Annual Monitoring Report

Monitoring Year 6 of 7

601 East Stream Restoration Project
NCDMS Contract No.: 004925
NCDMS Project No.: 95756
USACE Permit Action ID: 2013-00265
DWR Project No.: 14-0547

RE: 601 East Stream Restoration Site: MY5 Monitoring Report (NCDMS ID 95756)

Figure 2a

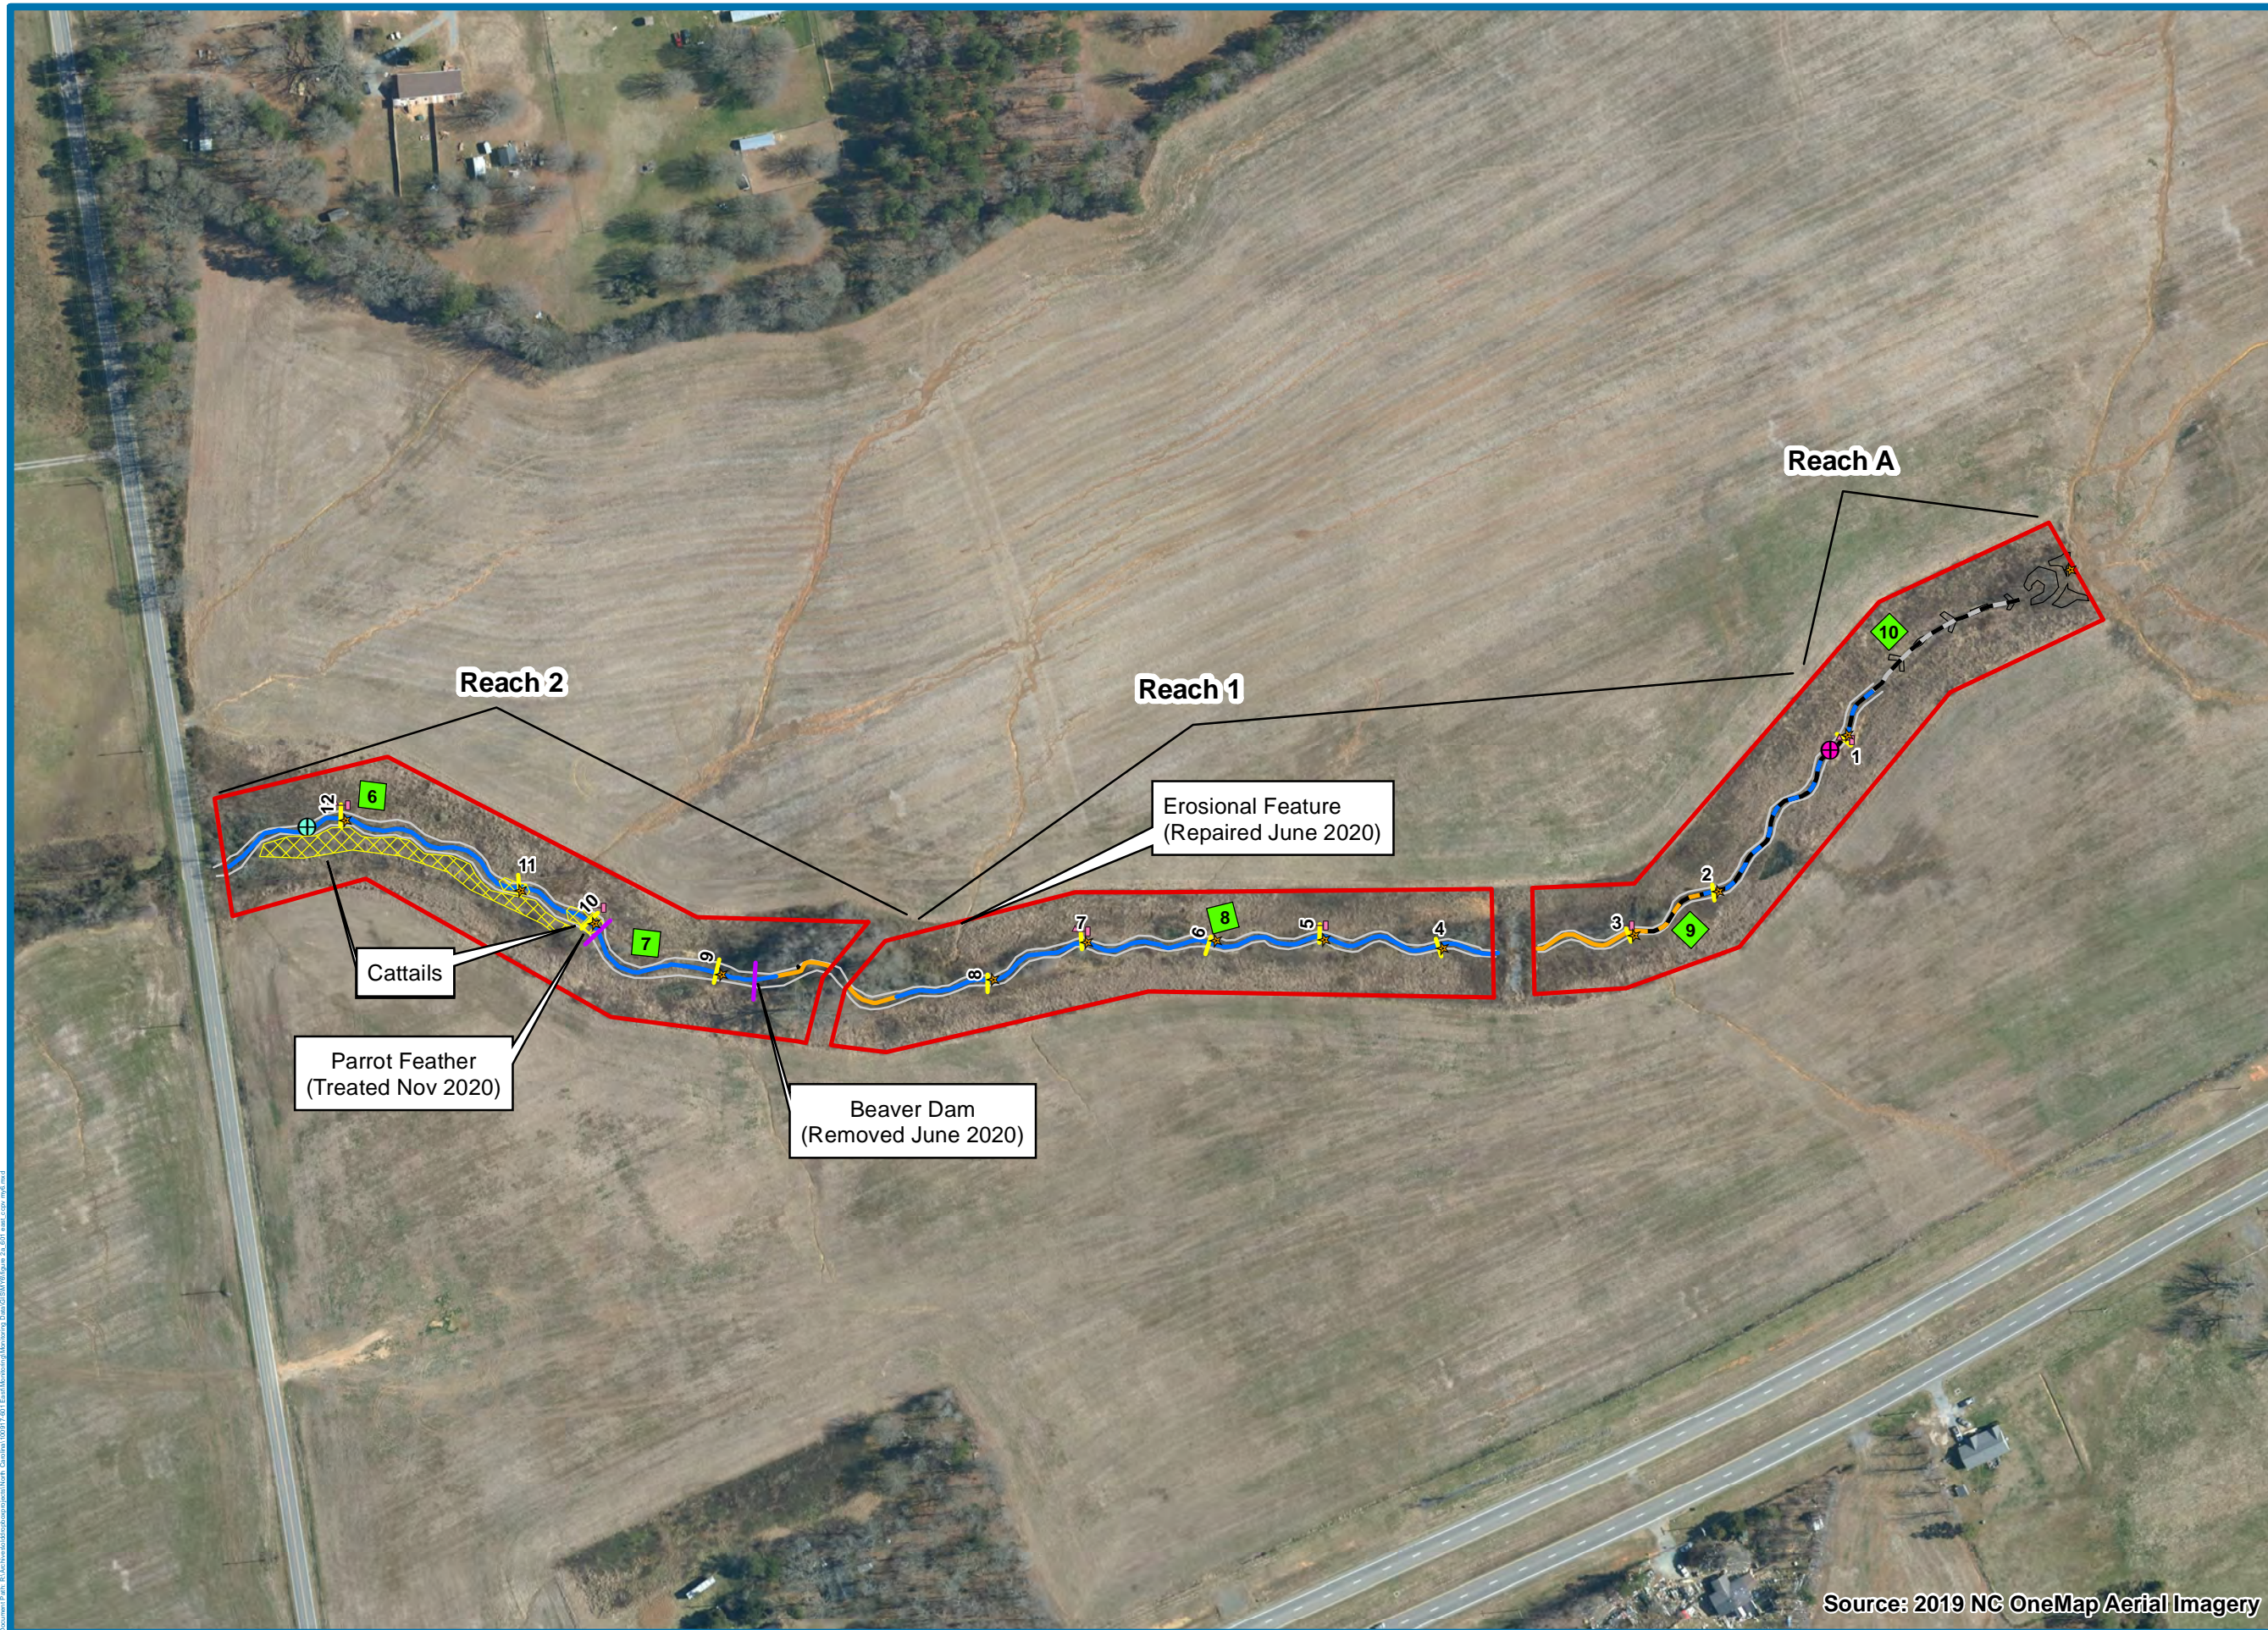
Section 1.4.1 Vegetation: This section notes that one area of encroachment was observed and repaired in June 2020. This area is also shown on the CCPV map/s. Please briefly discuss how this encroachment was addressed/ repaired. Was additional permanent marking and/ or signage added to the area to avoid future encroachment? Please also indicate when this area was replanted and approximately how many plants (include species) were installed.

Section 1.4.2 Stream Geomorphology: The report text and CCPV maps indicate that two (2) beaver dams were removed in June 2020 and two (2) beaver dams were removed in November 2020. Beaver have been a persistent issue on the site. Were beaver also trapped as part of the dam removal efforts? Please update the text accordingly.

[The encroachment repair included installing t-posts, horse tape, and easement signage along the easement boundary as well as planting 60 three-gallon container trees. The planting was done in June 2020 and species included sycamore, river birch, and willow oak. This has been added to Section 1.4.1.](#)

[The beaver dams were no longer active therefore beavers were not trapped in 2020. RES inspects sites quarterly and will perform beaver management \(dam removal and trapping\) as necessary throughout the remainder of the monitoring period. This was added to Section 1.4.2.](#)

MY6 2020 601 East Reach 1 Flow Gauge

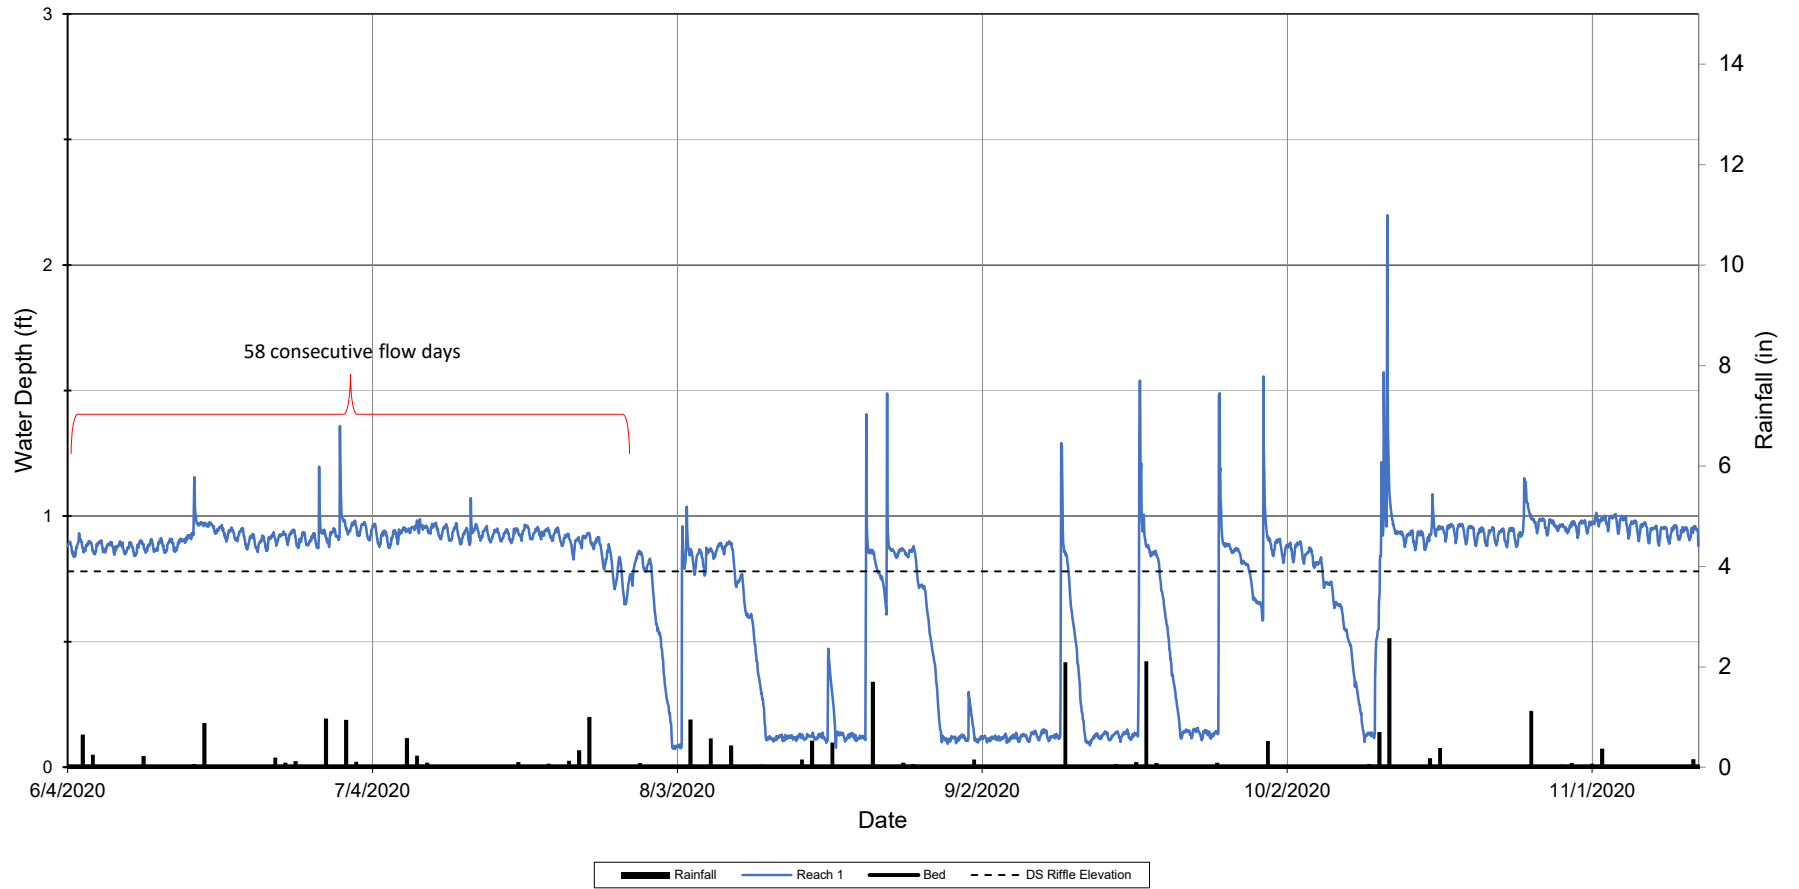
Appendix E – Flow Gauge Graph: DMS recommends showing the start and end points of the 58 days of consecutive flow reported.

Note that the data in the flow gauge figure is not plotted correctly in excel. Use the scatter plot (x,y) chart type, then add a line, rather than selecting the line chart type.

Done.

The line chart type has been changed to the scatter plot chart type.
